<b>SKIPPER DATA BULLETIN</b>		<i>Number</i>	SDB_DL850_14
<i>For System</i>	<i>Service</i>	<i>Date</i>	25.9.09
<i>Serial from / to</i>	< DT XX090199	<i>Author</i>	PC
<h1>Upgrading to SW 4.02.03 with New PLD (LG-T001)</h1>

### Changing the PLD in the transceiver (LG-T001 )

## Release notes for 4.02.03

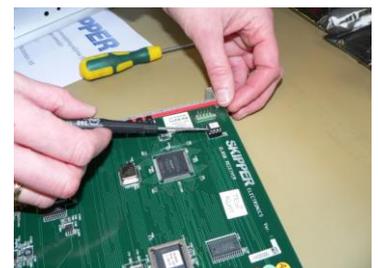
1. Open the transceiver cabinet and turn off the power.
2. Remove the Receiver card (furthest to left with 3 LEDs)
3. Remove the existing PLD and insert the new, making sure pin 1 is in correct place (the 'notch' should face up)
4. Reseat and fasten the card. Turn on power.

The Status screen of the display should now say that PLD version 1.00.00 is installed (if it says 0.00.00 in red, then the old version is installed)
